INITIAL FIRE SAFETY INSPECTION REPORT

Alpha Clothing Limited (Extension)

RSC ID: 26363

Date: 13-Aug-2025

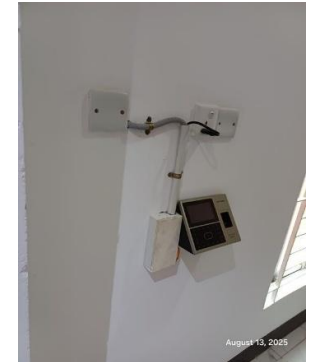
SI No.	Category	Findings	Required Action	Remediation Time Frame
F-1	Means of Egress	<p>The exit stair enclosures are not separated from work areas and other spaces on each floor by fire-rated construction.</p> <p>Location: Alpha Tower-3.</p> <p>Non-Compliance Reason: (i) Slab above fire door are less thick and does not provide 2.0 hour fire resistance rating. (ii) Unsealed penetration in staircase wall and few joint box compromises the fire resistance rating of partition wall. (iii) Few fire doors are not latched properly and also not interfaced with FACP and (iv) Manual and certificates are not available during the visit. & (v) clearance under the bottom of door is found more than 19mm.</p>	<p>The exit stair enclosure shall be provided with a minimum 1-hr fire resistance rating for buildings with 3 or fewer stories and a minimum of 2- hr. fire resistance rating for buildings 4 or more stories. Provide 1-hr. fire rated door and seal all penetrations and openings by 1 hr. fire rated fire rated barrier construction for building with 3 or fewer stories. Provide 1.5 hr. fire rated door and seal all penetrations and openings by 2 hr. fire rated fire rated barrier construction for building with 4 or more stories in accordance with section 6.3.1.2 of RSC Technical Guidelines (Standard)¹ V1.0.</p> <p>Ensure that the fire doors are self-closing and positive latching and that they are provided with fire exit (panic) hardware where serving production floors. If fire doors are required to be held open for functional reasons, provide automatic closing devices tied to the fire alarm system.</p> <p>Keep proper datasheet & certifications for installed fire doors & accessories on-site for verification. The clearance under the bottom of a door shall be a maximum of 3/4 in. (19 mm).</p>	Within 3 Months

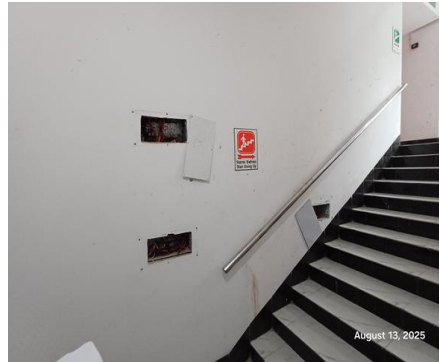
SI No.	Category	Findings	Required Action	Remediation Time Frame
F-2	Means of Egress	<p>Unsealed penetrations and openings are located in exit stair enclosures. Electrical cable, Networking cable or other utility lines passing through the exit enclosure.</p> <p>Location: Both the staircase of Alpha tower-3.</p>	<p>No other penetration into and through the exit enclosure except for fire alarm equipment electrical raceway, required exit doors, sprinkler piping, standpipes, and electrical conduit serving the exit enclosure is permitted in accordance with section 6.14.4 of RSC Technical Guidelines (Standard)¹ V1.0. So, relocate the electrical wires/raceways to somewhere else avoiding the exit enclosure, and seal the created unprotected openings with a minimum of 1.5 hours listed/certified fire-rated materials. Installation shall be as per manufacturer published installation guideline and the certification authority guideline to ensure the fire-rating. Or seal the penetration by 2-hr masonry construction.</p>	Within 3 Months

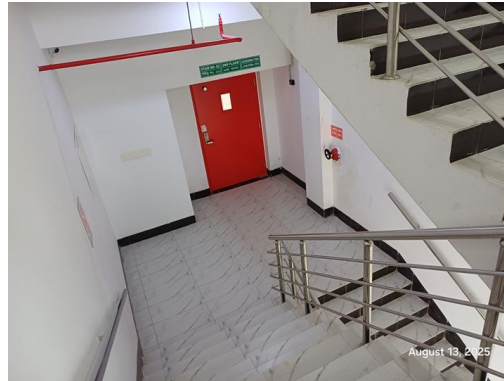
SI No.	Category	Findings	Required Action	Remediation Time Frame
F-3	Means of Egress	<p>Storage areas discharges directly into the exit stair enclosure.</p> <p>Location: Accessories Store on 2nd floor and finished goods store on 3rd floor.</p>	<p>Openings from exit enclosure to Storage areas shall be provided with a vestibule with fire rated construction and openings in accordance with section 6.14.3 of RSC Technical Guidelines (Standard)¹ V1.0. Provide a min 1-hr fire rated door on the exit stair side and a 1.5 hr. fire rated door on the Store, generator, sub-station room side . Ensure that the fire rating of the vestibule construction matches that of the exit stair enclosure as per RSC Technical Guidelines (Standard)¹ V1.0. section 6.14.3. The minimum width for vestibules shall not be less than 1.1m and length 1.8m.</p>	Within 3 Months

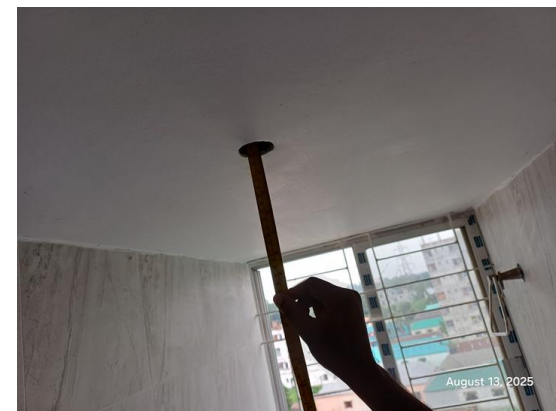
SI No.	Category	Findings	Required Action	Remediation Time Frame
F-5	Fire Rated Construction	<p>Penetrations through floor/ceiling assemblies are found unsealed.</p> <p>Location: All Floors of Alpha Tower-3.</p> <p>Non-compliance reason: (i) BBT/Electrical Conduits passing through floor to floor and (ii) UPVC Plumbing pipe penetrations are covered by false slab which has less fire resistance rating than required and unsealed penetration found on false slab.</p>	<p>Seal all penetrations and openings in floor/ceiling assemblies by a listed through-penetration fire stop system tested in accordance with ASTM E814 or approved alternative standard to maintain minimum 3-hr. fire resistance rating. Installation shall be as per manufacturer published installation guideline and the certification authority guideline to ensure the fire-rating in accordance with section 4.7 of RSC Technical Guideline (Standard)</p> <p>Or,</p> <p>Provide a minimum 2-hr fire rated shaft to separate the penetration from each floor if required.</p>	Within 3 Months

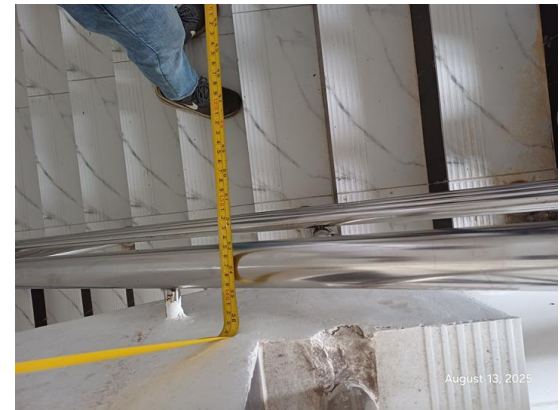
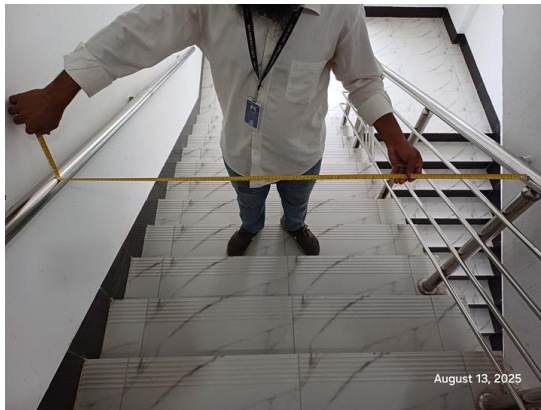
SI No.	Category	Findings	Required Action	Remediation Time Frame
F-10	Means of Egress	<p>Stair clear width was found less than 60 in.</p> <p>Location: Both Staircase of Alpha Tower-3.</p> <p>Available Stair Width: Width of Stair-1: 4'-6" and Width of Stair-2: 4'-6".</p>	Stairs shall have a minimum clear width of 60 in. for all industrial occupancies as per RSC Technical Guideline (Standard) section of 6.5.6.	Within 3 Months

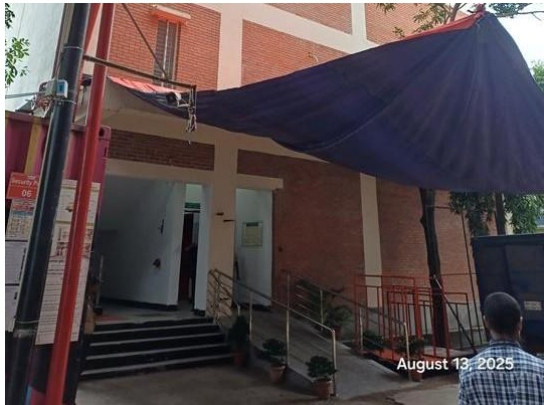
SI No.	Category	Findings	Required Action	Remediation Time Frame
F-12	Means of Egress	<p>Stair width is more than 87 inch but no intermediate handrails has been provided. Location: S-E Stair-1 Discharge in Alpha Tower-3.</p> <p>Handrails are not provided on both sides of exit stair, may pose as a falling hazard during evacuation. Location: New Compressor Room Discharge.</p>	<p>Provide handrails on both sides of the exit stair. New handrails shall have a minimum height of 865 mm (34 in.) and a maximum height of 965 mm (38 in.) as measured from the leading edge of the tread. Intermediate handrails shall be provided when the stair width exceeds 2.2 m (87 in.).</p> <p>Open guards shall have intermediate rails or pattern such that a sphere 200 mm (8 in.) in diameter cannot pass through any opening up to a height of 865 mm (34 in.). Handrail shall construct in accordance with RSC Technical Guidelines (Standard)¹ V1.0 Section 6.12.</p>	Within 3 Months

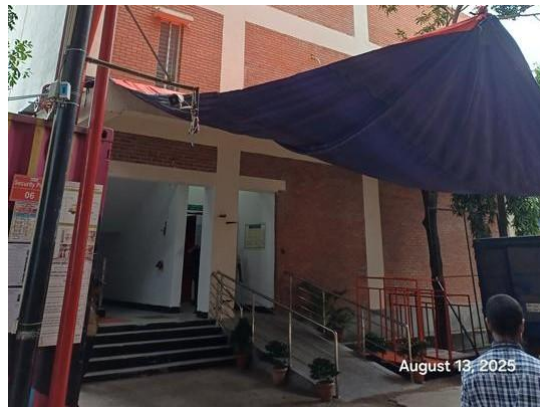
SI No.	Category	Findings	Required Action	Remediation Time Frame
F-13	Means of Egress	<p>Changes in level was found 30 in. where RSC Technical Guidelines (Standard)¹ V1.0 Section 6.9 or 6.10 doesn't meet.</p> <p>Location: S-E Stair-1 Discharge in Alpha Tower-3.</p>	<p>Changes in level exceeding 535 mm (21 in.) in elevation shall meet the requirements for stairs in 6.9 or ramps in 6.10.</p> <p>The change in level shall be readily apparent and if not, marked with additional signage or floor markings.</p>	Within 3 Months

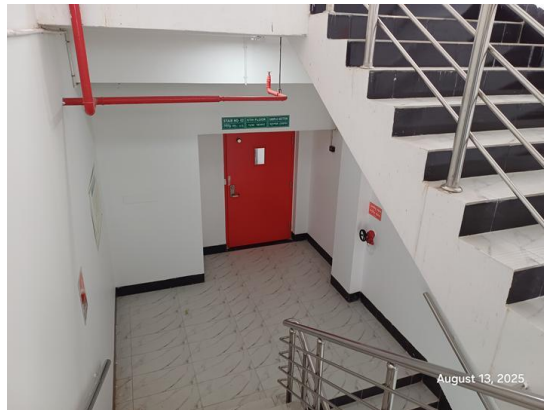
SI No.	Category	Findings	Required Action	Remediation Time Frame
F-15	Means of Egress	<p>Building does not have occupant load signs at required locations on all floors.</p> <p>Location: Alpha Tower-3.</p>	<p>Post the occupant load for every assembly and production floor in a facility in a conspicuous space near the main exit or exit access doorway for the space in accordance with RSC Technical Guidelines (Standard)¹ V1.0 Section 6.4.4.</p>	Within 1 Month

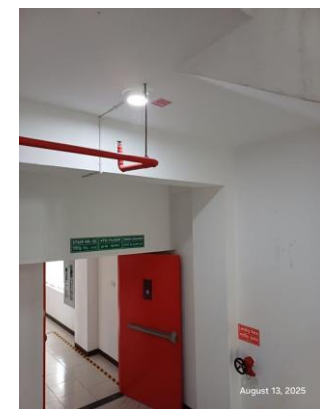
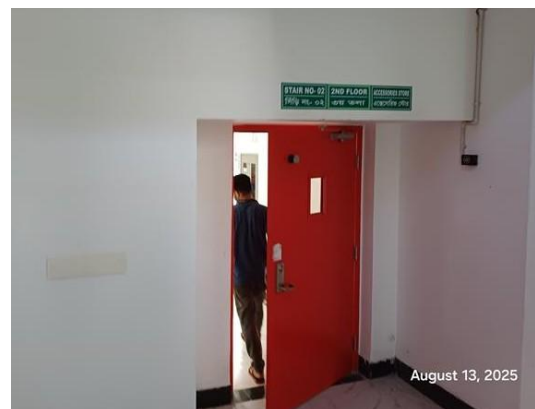
SI No.	Category	Findings	Required Action	Remediation Time Frame
F-16	Means of Egress	<p>Exit stairs serve more than 5 stories and do not have required re-entry provisions on all floors.</p> <p>Location: Alpha Tower-3.</p>	<p>Every door in a stair enclosure serving more than 5 stories shall be provided with re-entry unless it meets RSC Technical Guidelines (Standard)¹ V1.0. Section 6.8.3.1.</p>	Within 2 Months

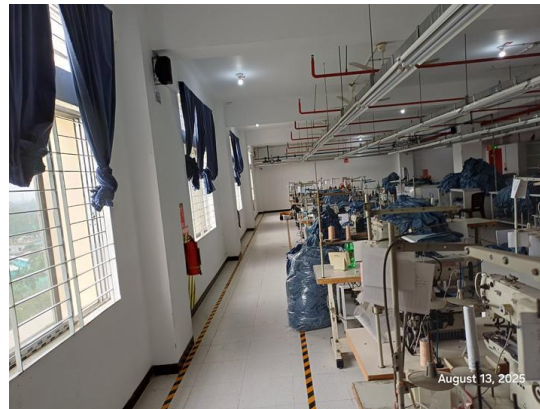
SI No.	Category	Findings	Required Action	Remediation Time Frame
F-17	Means of Egress	<p>Directional signs are not provided where direction of the path of travel to an exit has changed.</p> <p>Location: All floor of Alpha Tower-3.</p>	<p>Illuminated directional signs shall be provided where there is a change in the direction for the path of travel and the direction to an exit is not obvious in accordance with RSC Technical Guidelines (Standard)¹ V1.0 Section 6.11.3.</p>	<p>Within 1 Month</p>
